UNITED STATES PATENT AND TRADEMARK OFFICE

APPLICATION NO.	FILING DATE	FIRST NAMED INVENTOR	ATTORNEY DOCKET NO.	CONFIRMATION NO.
10/619,669	07/15/2003	Partab Jeswani	DP-307786	7172

Office Action Summary

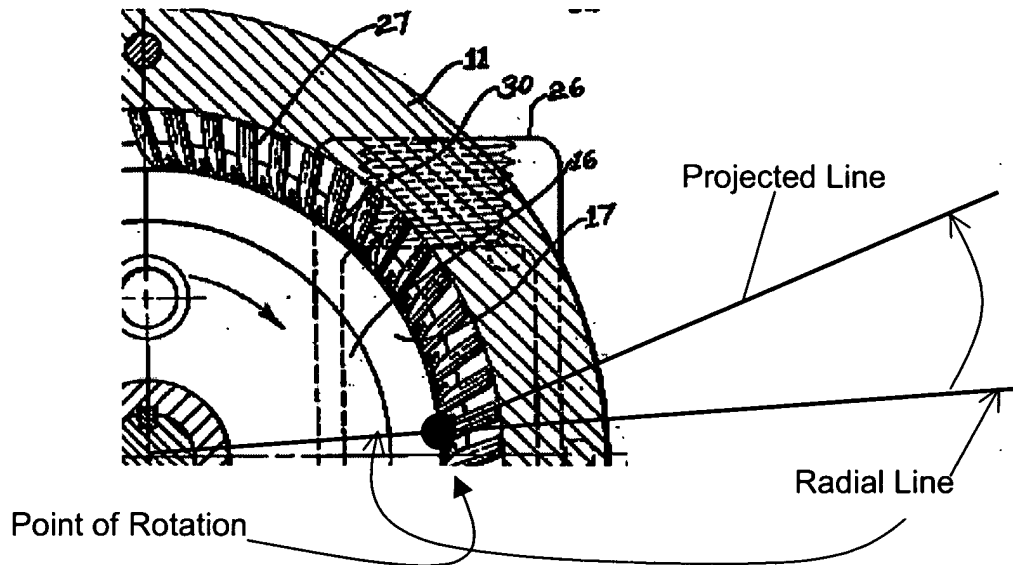
The Brady, Jr. reference (U.S. Patent No. 2,283,844) inherently requires, through the enabling figures, a point of rotation at the hub diameter through which a radial axis extends and each of the blades having a trailing edge being slanted by an angle by a line projecting from the trailing edge through said point. The annotated drawing below illustrates the rotation point and related lines.

The examiner submits that if the Brady, Jr. blades are to be slanted as shown, there is inherently a point of rotation of the hub outer diameter, otherwise, the blades would not be slanted since they would lie in the radial direction.
